LOUISIANA
POWER & LIGHT

SUBJECT: Waterford SES 3
Docket No. 50-382
Formal submittal of follow up items from SQRT audit

RESPONSE TO SORT ADIT

RESPONSE TO CE/PLANT ENGINEERING
CONFIRMATORY ITEMS FROM WATERFORD UNIT #3
SQRT RE-AUDIT

LOUISIANA POWER & LIGHT CO.
BATERFORD S.E.3. UNIT NO.3
CONTROL WIRING DIAGRAM

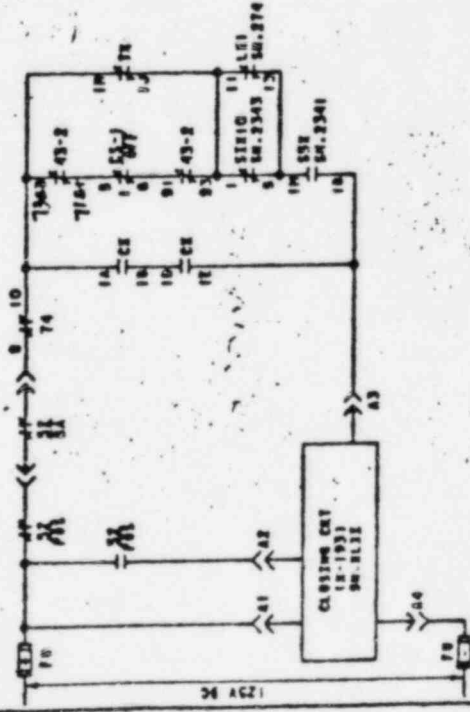
Please refer to the attached Control Wiring Diagram Dwg No. LOU 1564B-424, Sheet E365.

Furthermore, we have suggested that the wiring of the tripping contact 2-2 be modified to connect contact 2-2 in series with N.O. of SIS relay, this will prevent 2-2 from tripping the charging pump during the emergency operation, at the same time we will not suspend the protective function of the lube oil pressure switch. The existing lube oil pressure low alarm remains active during normal and emergency operation of the charging pump.
